Halton District School Board

Addendum No. 2

RFT 22-107 HVAC & Ventilation Upgrades - Rolling Meadows PS

PNF Project No. 29083 Dwg.No. E-5

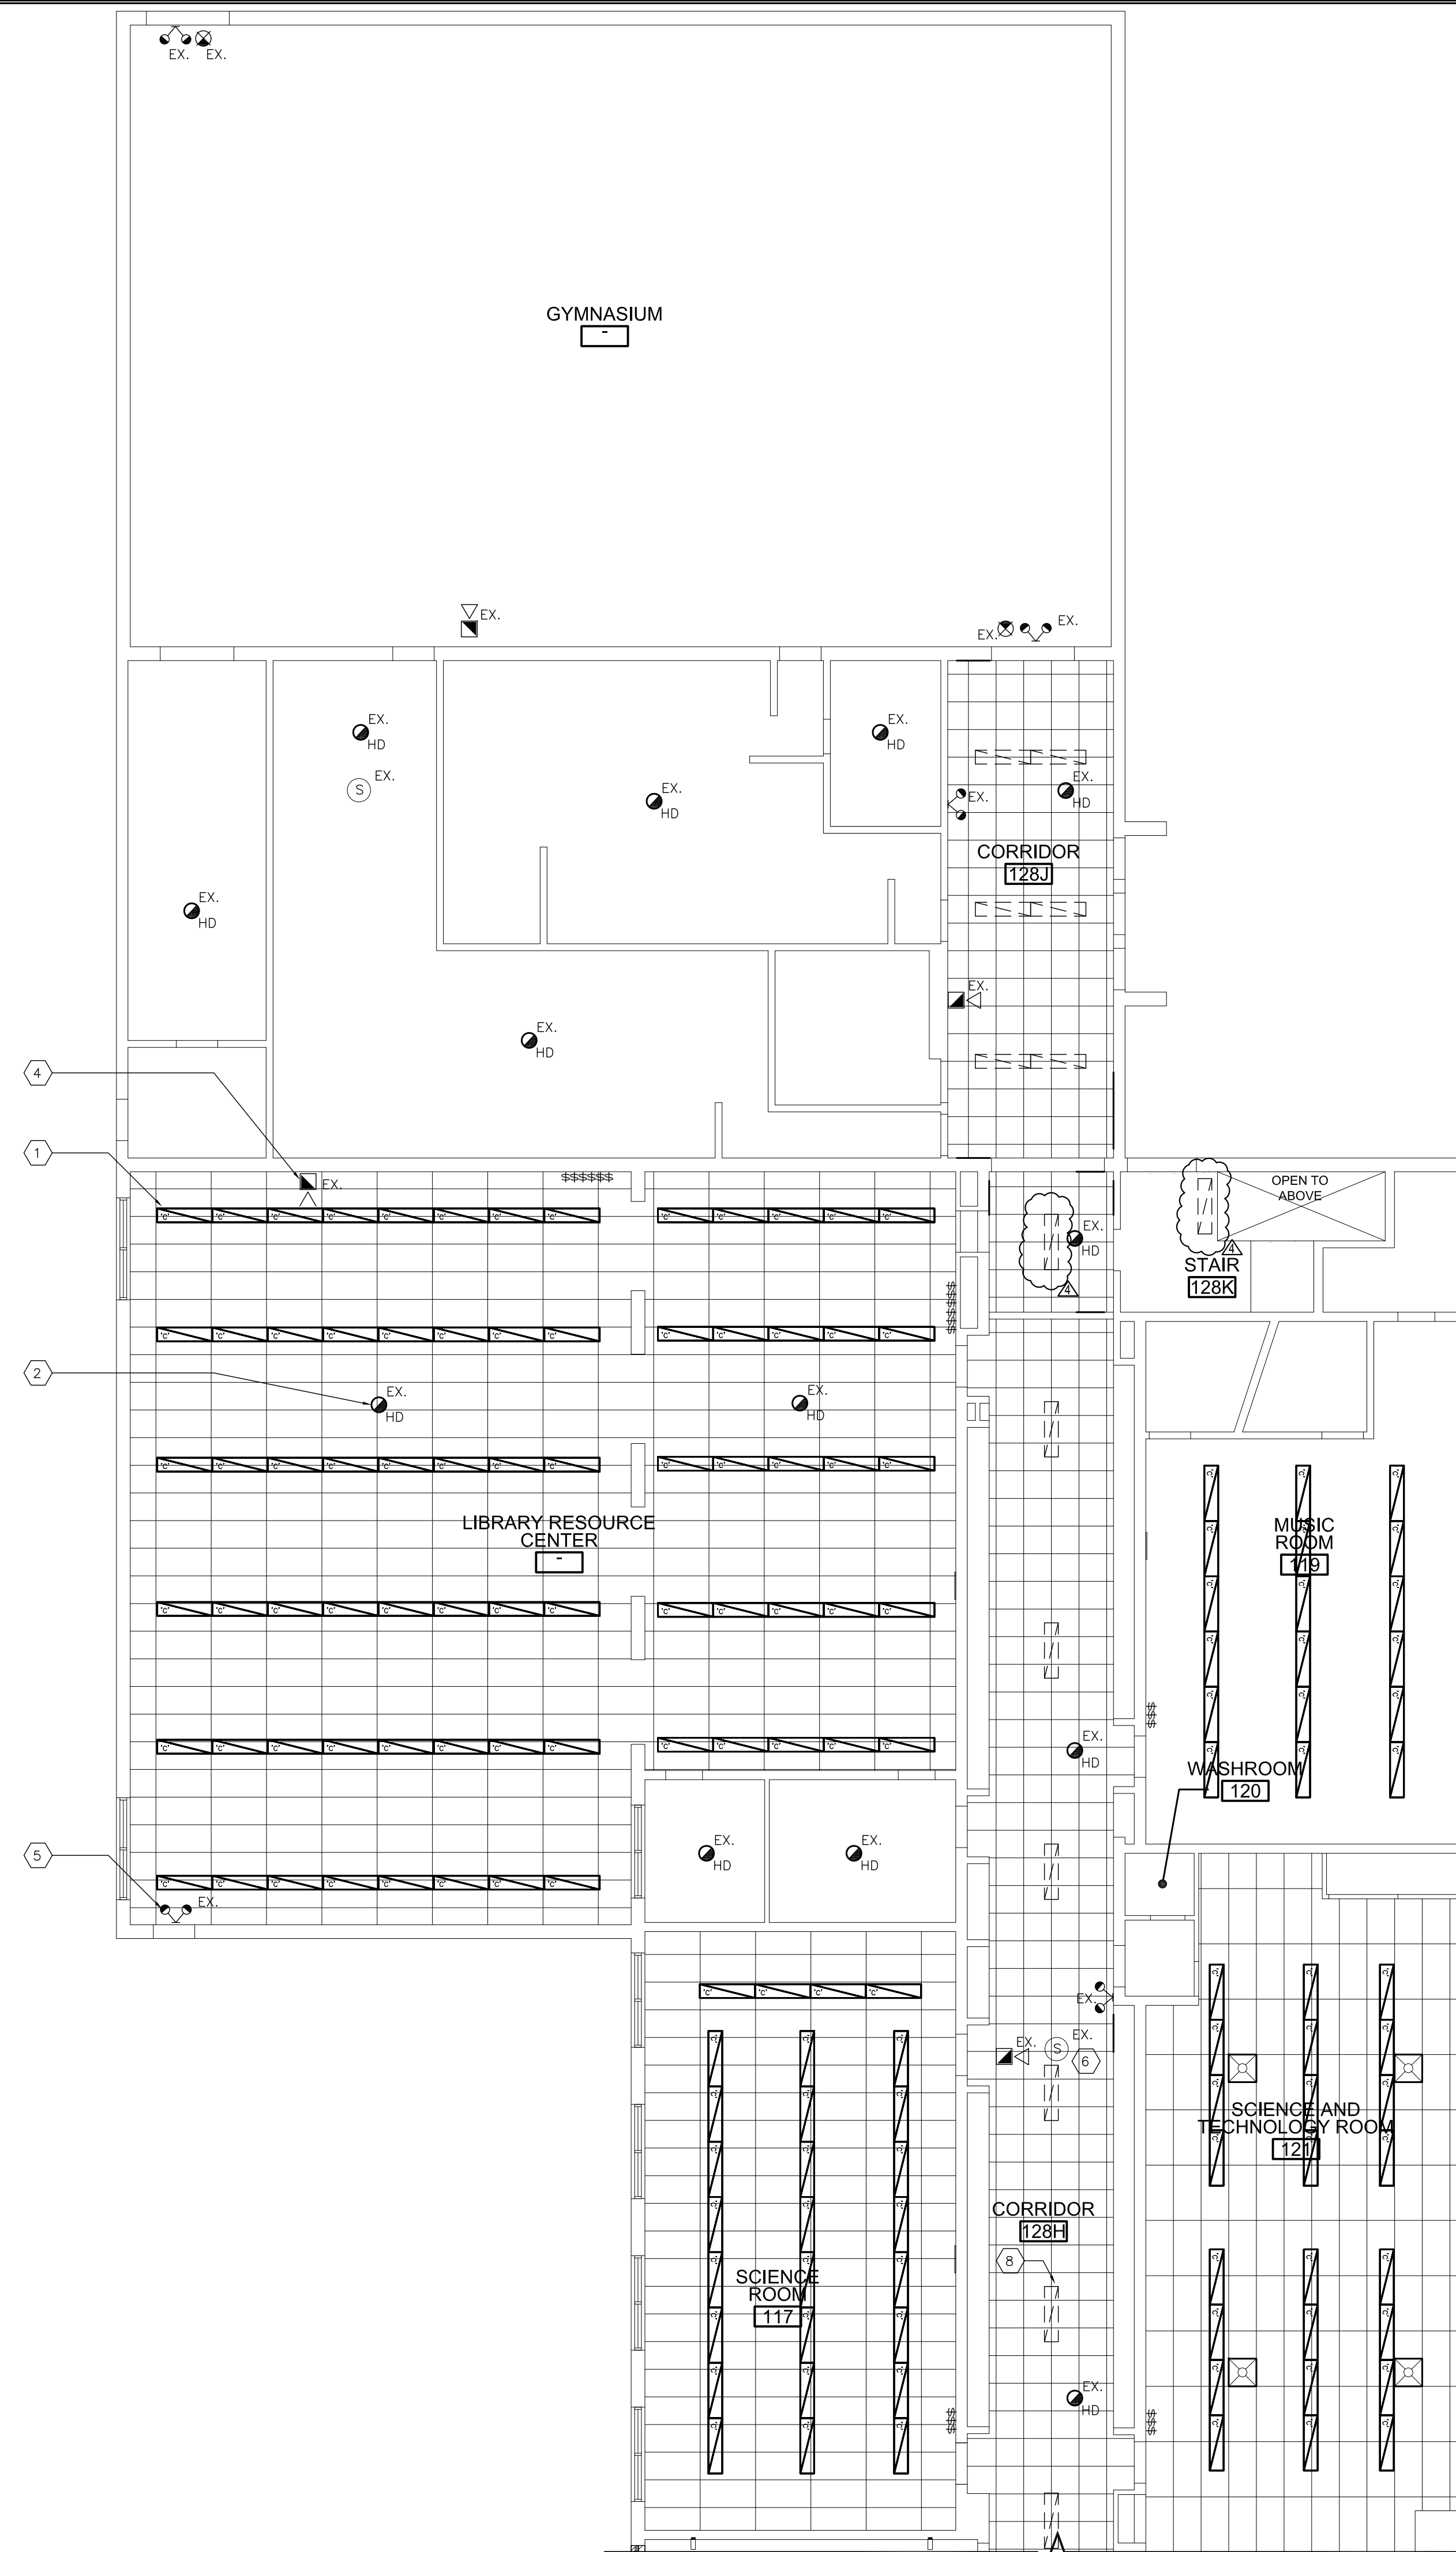
- Item 1** **Question:** Just confirming: are all corridor light fixtures to remain?
Answer: Yes
- Item 2** **Question:** Page E5 shows 2 type B fixtures. Legend states not used. Please confirm.
Answer: Light fixtures in corridors are existing to remain (see enclosed revised drawing E5)
- Item 3** **Question:** Page E6 in the stair lobby show new heat detector? Please confirm.
Answer: Heat detectors in corridors and stairs are existing to remain (see enclosed revised drawing E6)
- Item 4** **Question:** Page E11 & E12 both show panel DP-UV2. Please clarify.
Answer: Panel DP-UV1 is shown on drawing E11, and panel DP-UV2 is shown on drawing E12. (see enclosed revised drawing E11)
- Item 5** **Revision** – New panels DP-UV1 and DP-UV2 schedules have been updated (see enclosed revised drawing E13)
